P.O.A.D.P. PLAN

FM 1604 LOOKOUT

POADP # 597

P.O.A.D.P REVIEW

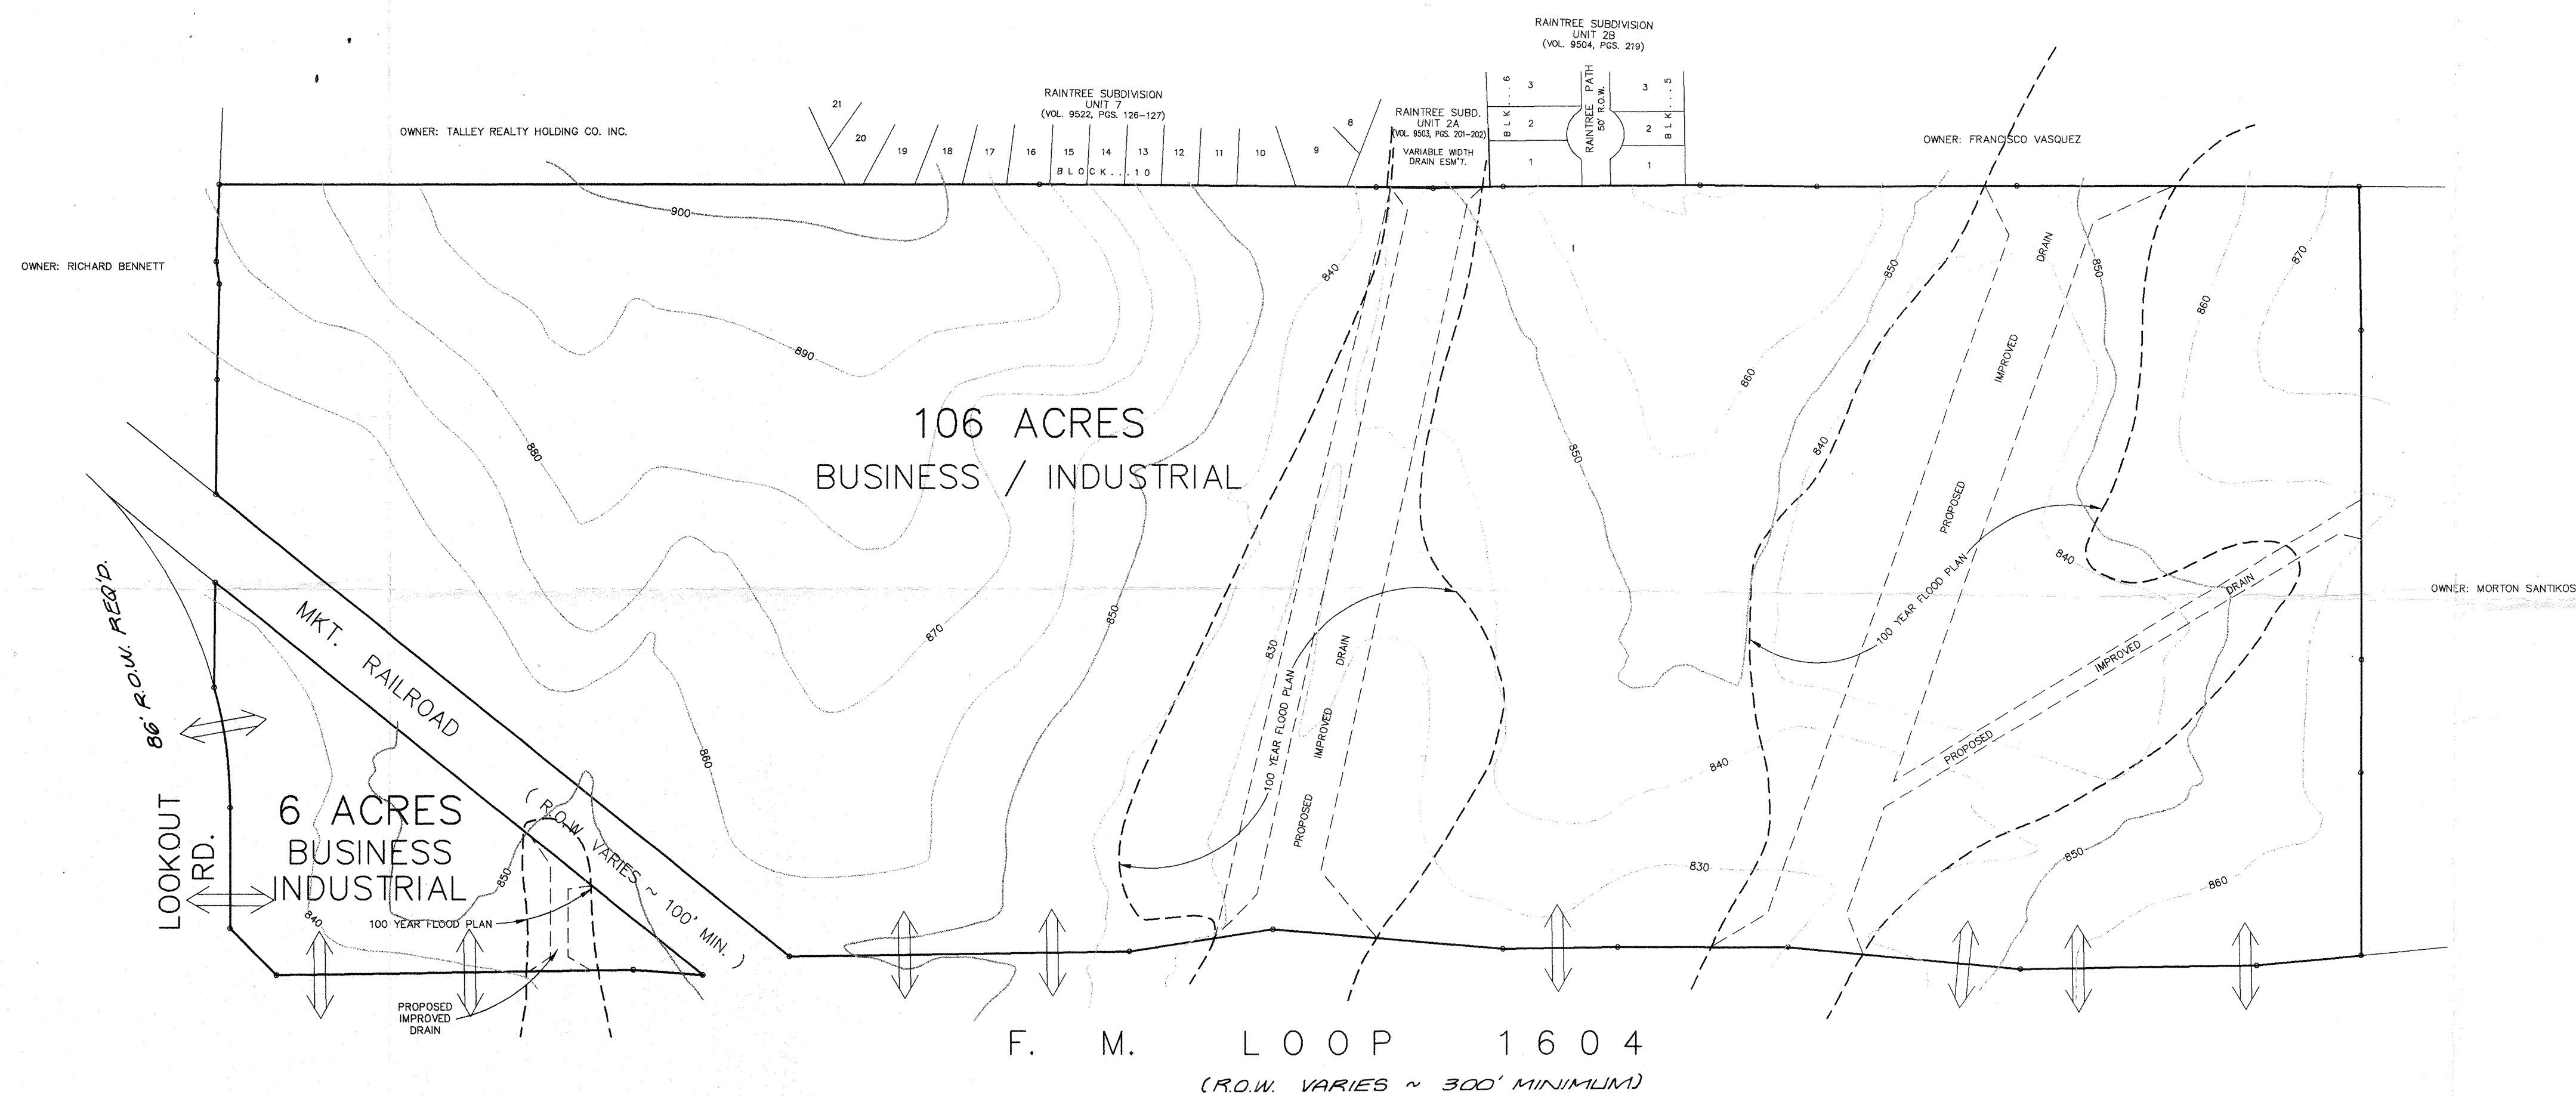
- Based on the topography, a Flood Plain Study and drainage review will probably be required during the platting process.
- Access and R.O.W. issues along State facilities will need to be resolved with the Texas Department of Transportation (TXDOT). For additional information about these requirements you can contact TXDOT at 615-5814.
- This development will need to comply with tree preservation ordinance #85262. For additional information about these requirements you can contact Building Inspections at 207-7102.

For residential development directly adjacent to State ROW, the developer shall be responsible for adequate set-back and/or sound abatement.

The 106 acre business/industrial tract is eligible for a maximum combined total of Six(6) access points, based on the overall combined Loop 1604 frontage. The 6 acre business/industrial tract is eligible for a maximum combined total of two(2) access points, based on the overall combined Loop 1604 frontage. Locations of access points will be as directed by "Regulations For Access Driveways to State Highways".

Permit applications along with plans for street, driveway, utility, sidewalk and drainage construction must be submitted to the Texas Department of Transportation for review and approval before working on highway ROW. TxDOT requires that a recorded plat accompany all driveway permit applications. The Owner/Developer is responsible for preventing any adverse impact to the existing drainage system within highway ROW.

Comments: Flood plain requirements and
Drainage easements will be require and
address during the platting process

- ROW min. on 1604
- ROW on lookout
- Drainage
- TIA
